RE: **ABC Building Expansion**
Grading Plan Stamp Date: 1/23/19
Drainage Plan Stamp Date: 1/16/19
Hydrology File: H14D001B

Based on the submittal received on 1/23/19, the grading and drainage plan is re-approved for Site Plan Building Permit, Grading Permit, and Building Permit.

Re: ABC Building Expansion, File # H14D001B

C1

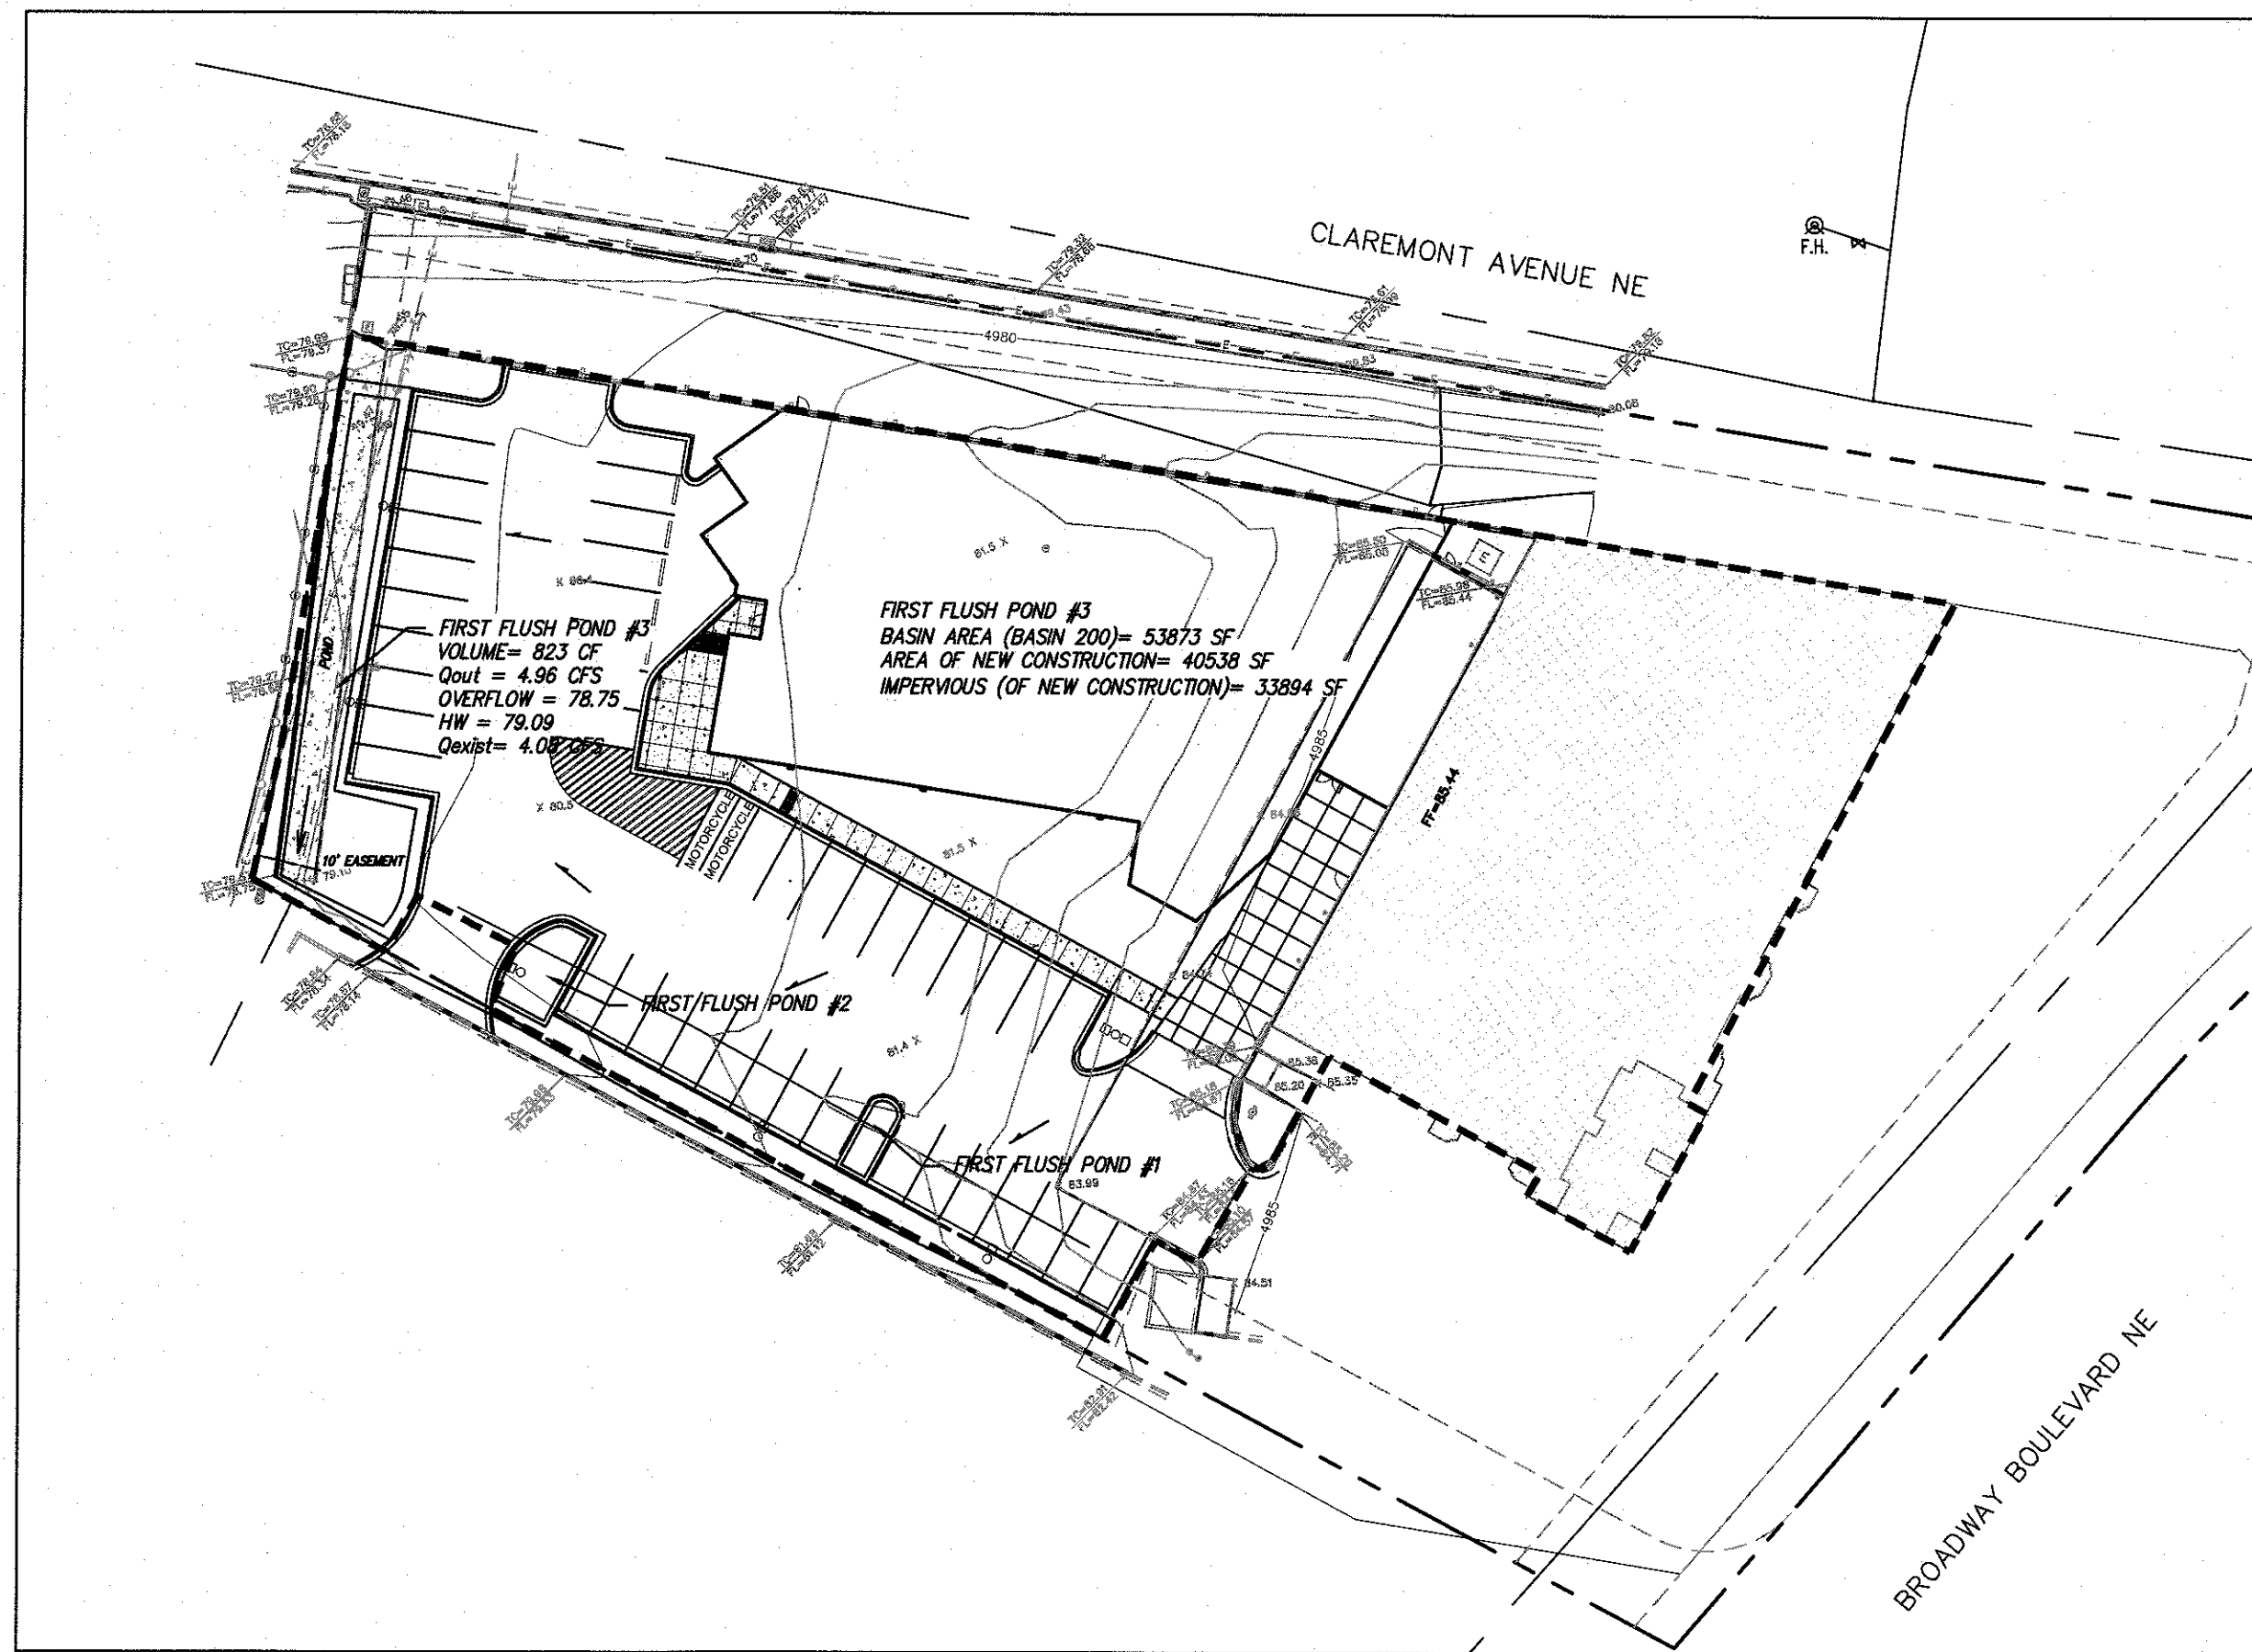
Please find enclosed the Grading and Drainage Plan, Drainage Management plan, original letter of approval, and DTIS for the ABC Building Expansion. The plan was originally approved September 28th, 2018. The resubmission is due to Grading and Drainage Plan revisions and additional detail to include roof drains.

1 1/23/2019 ROOF DRAINS

C2

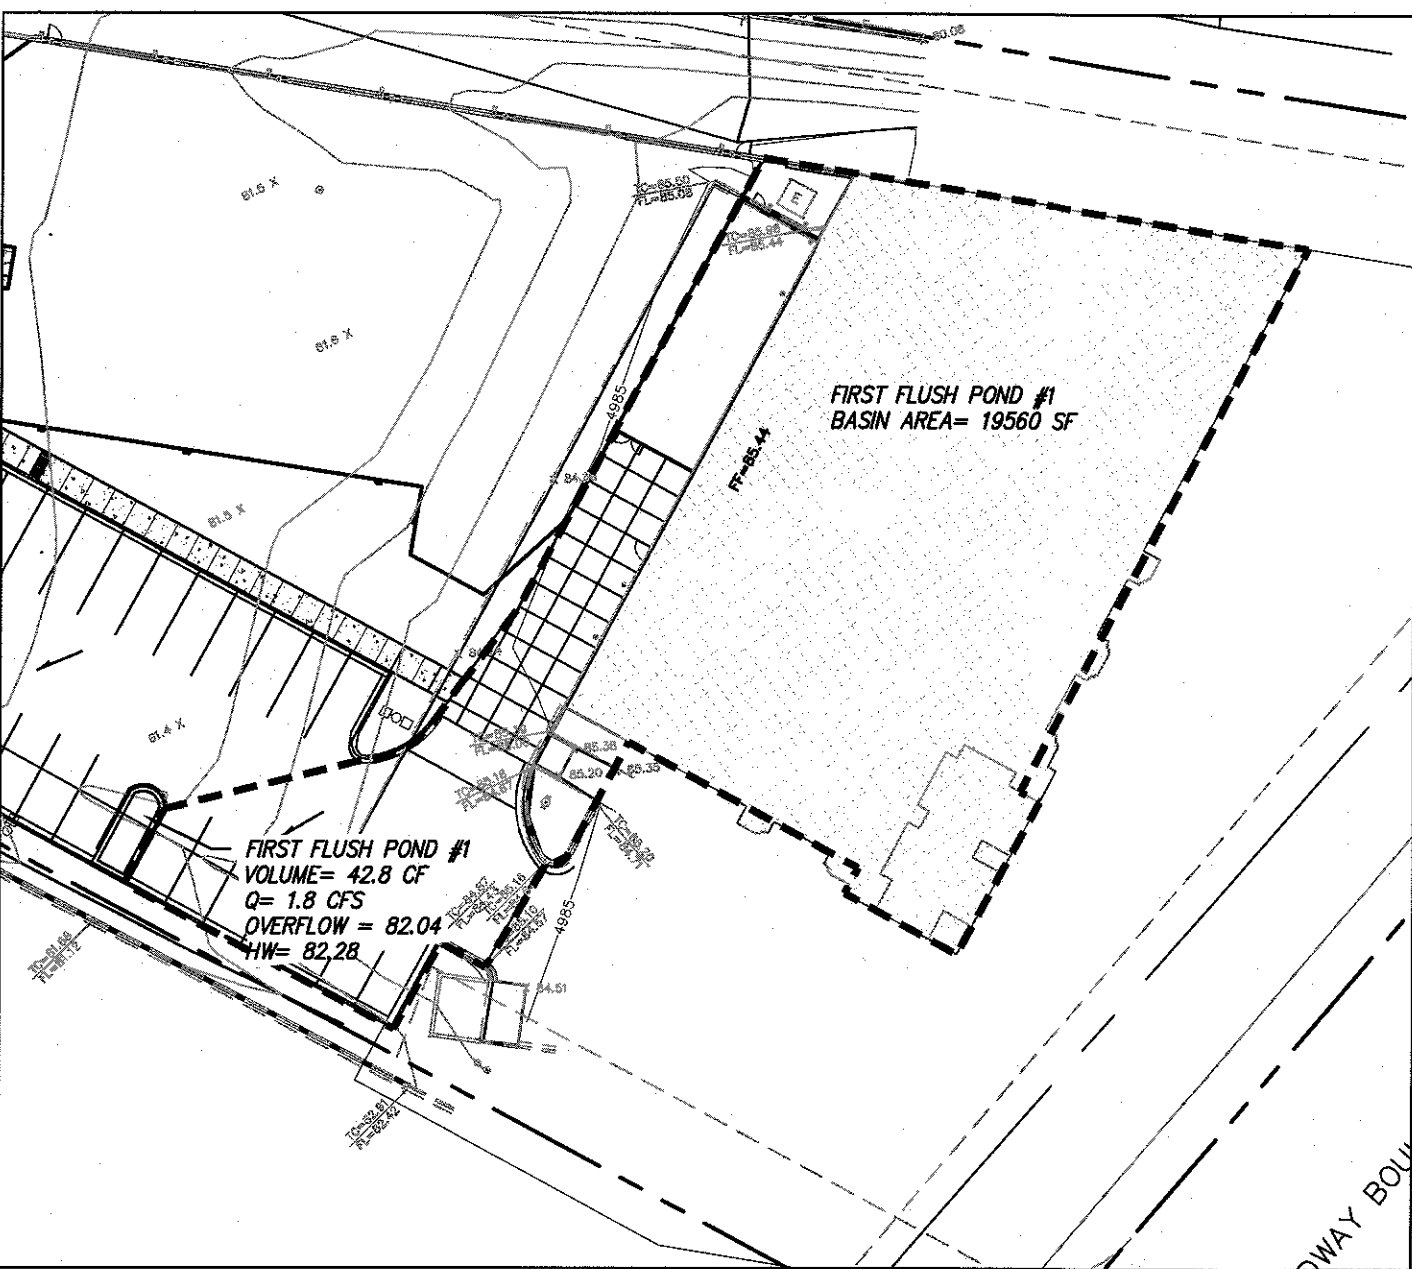
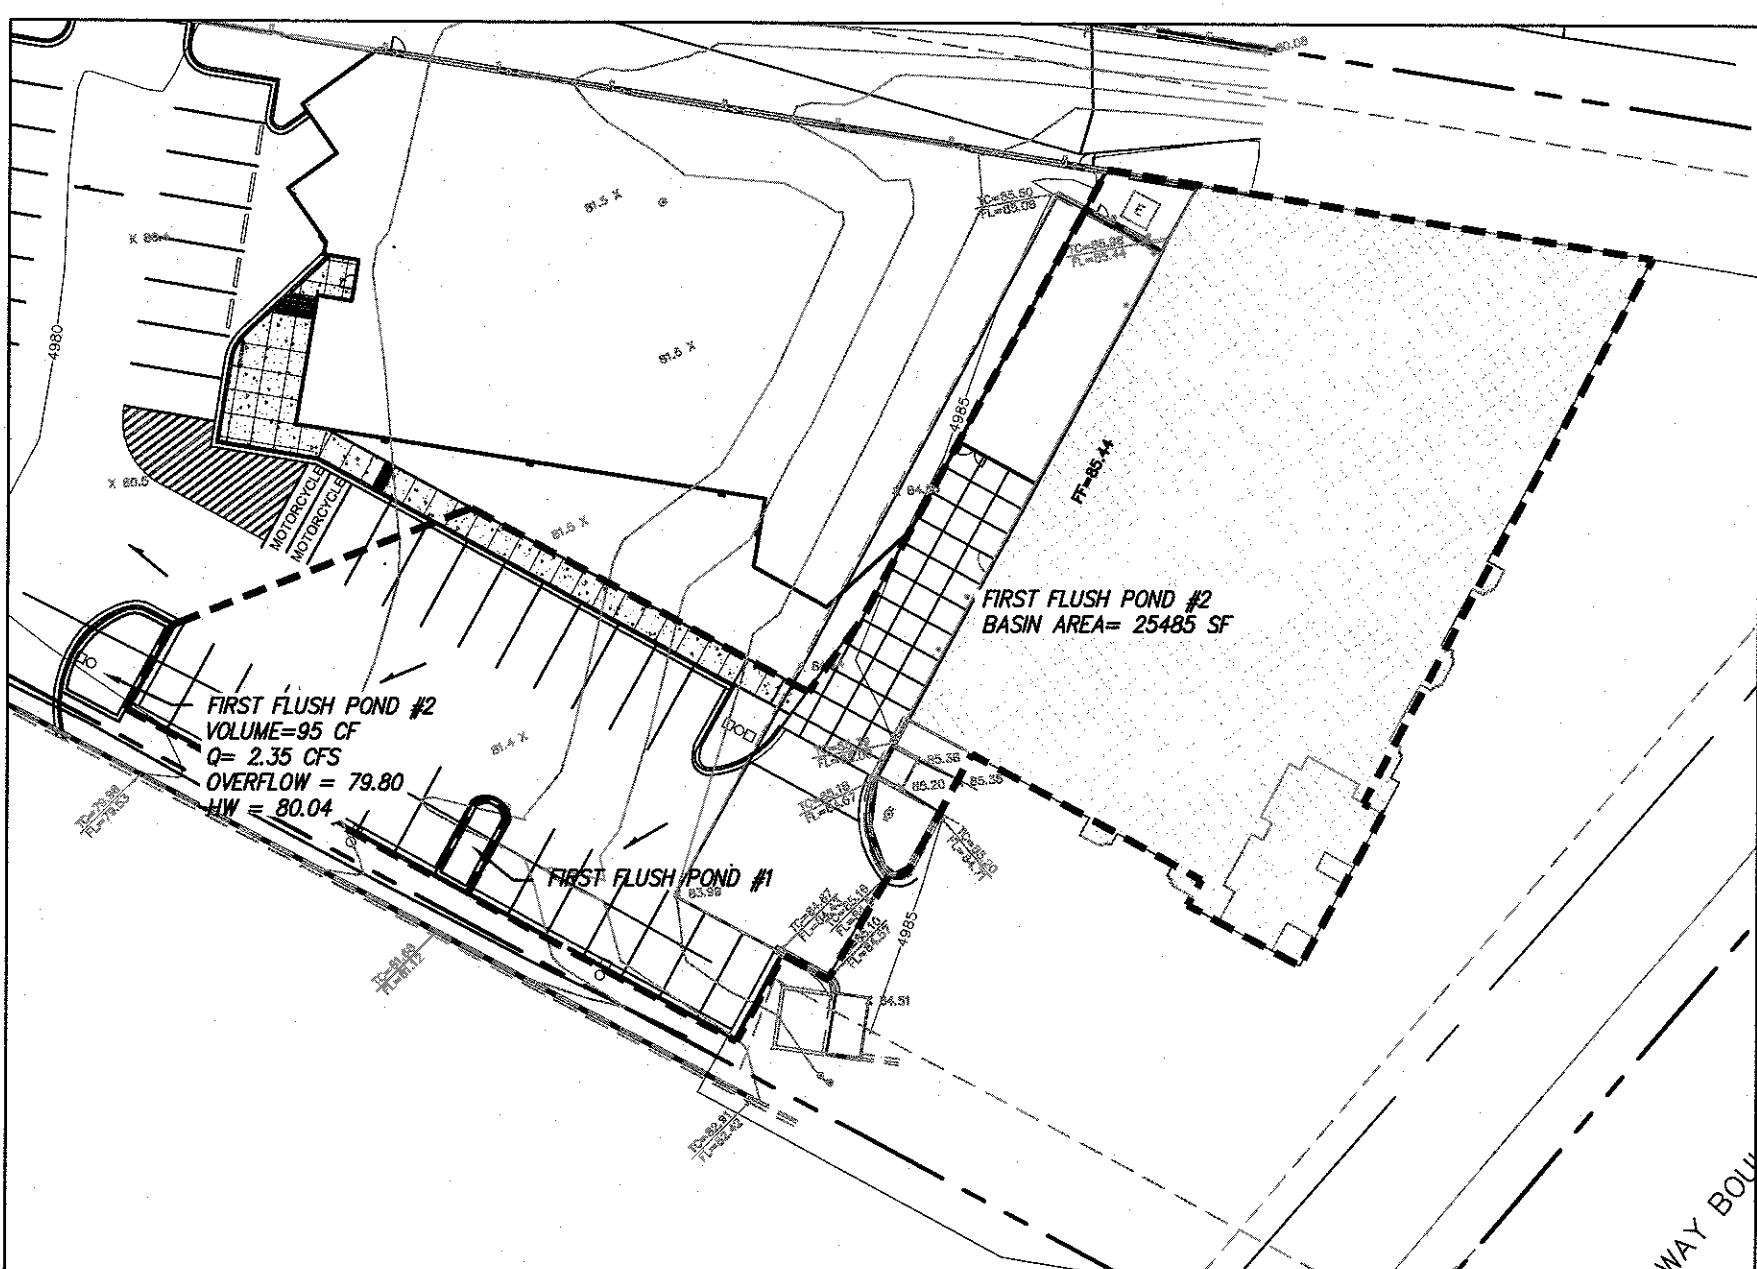
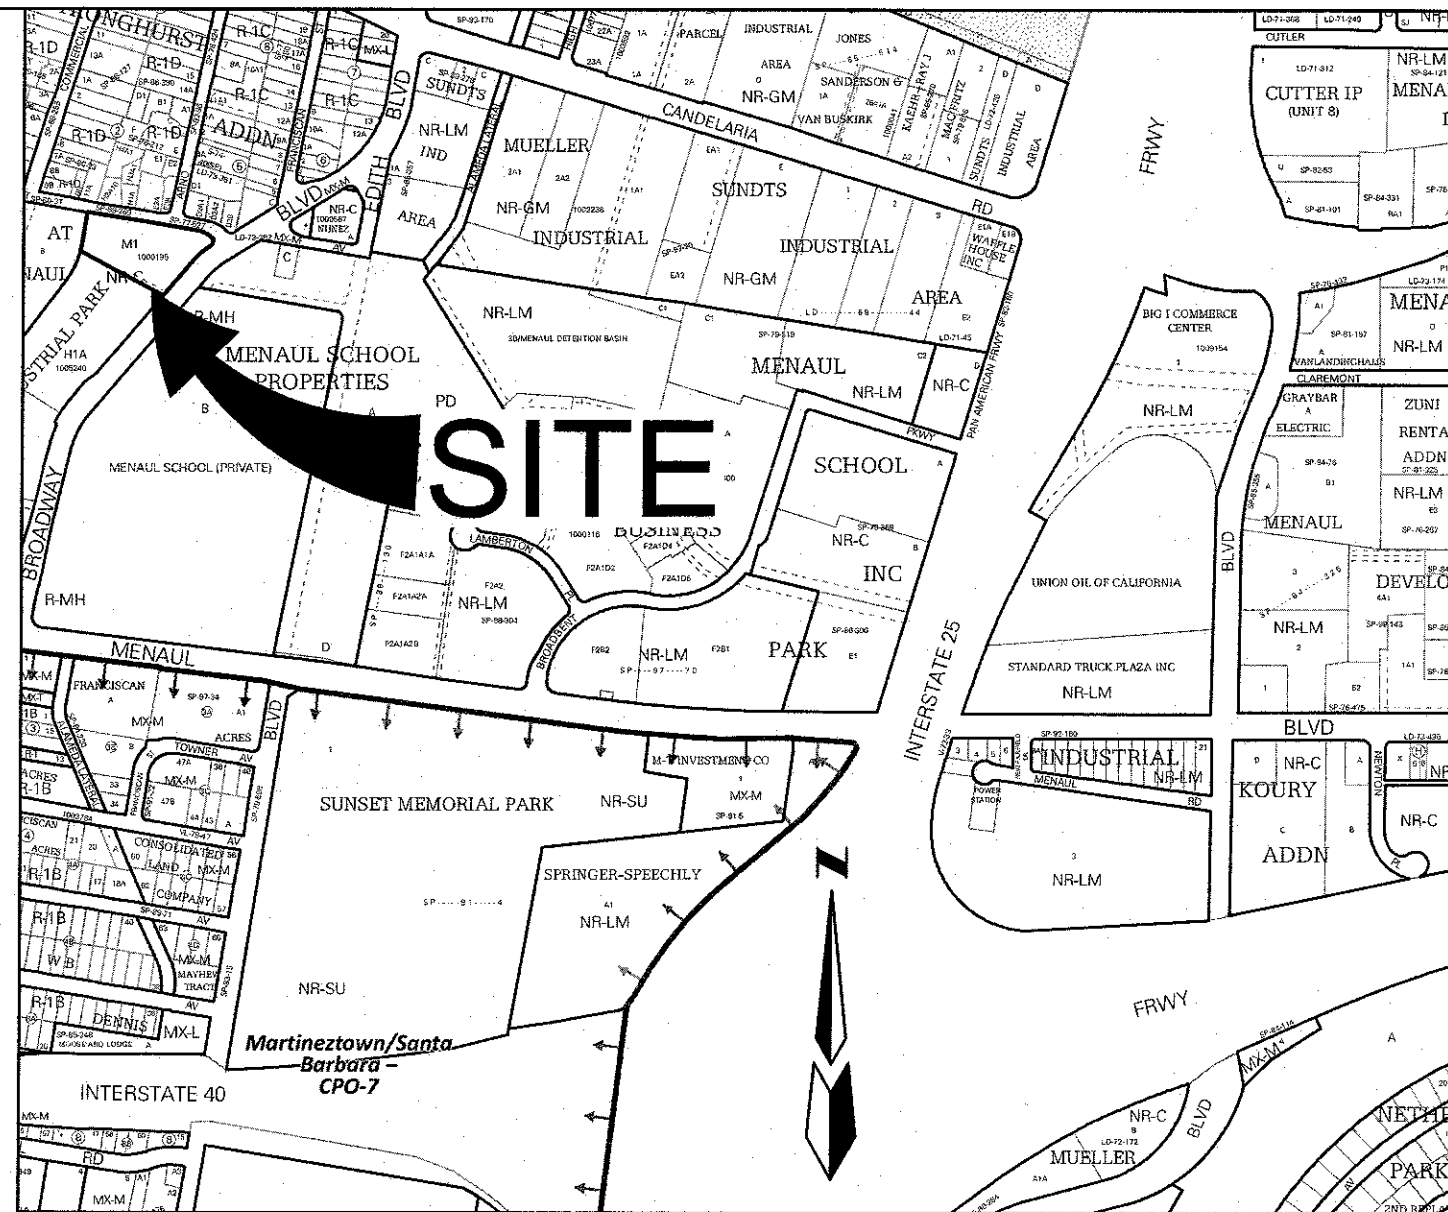
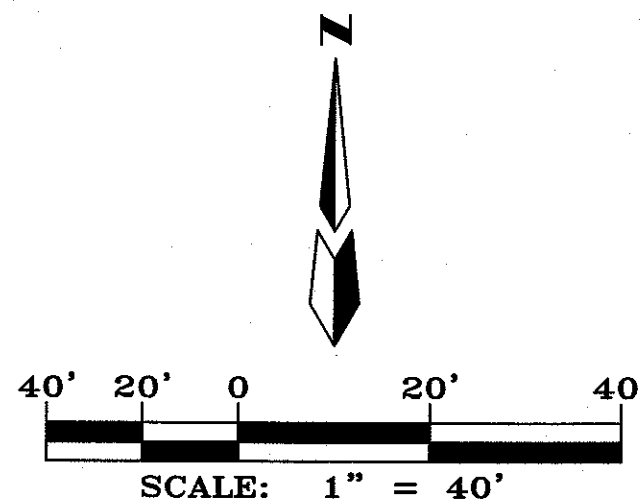
The overall drainage trends and the First Flush capture system remain the same. However, the Drainage Management Plan is also included with the available First Flush volume to pond #3 revised to 1336 CF from 960 CF. The additional flow is from the existing higher elevations (roof of existing building); however, the required first flush volume generated by the area of new construction remains the same. As such, the first flush capture design is unchanged from the originally approved design.
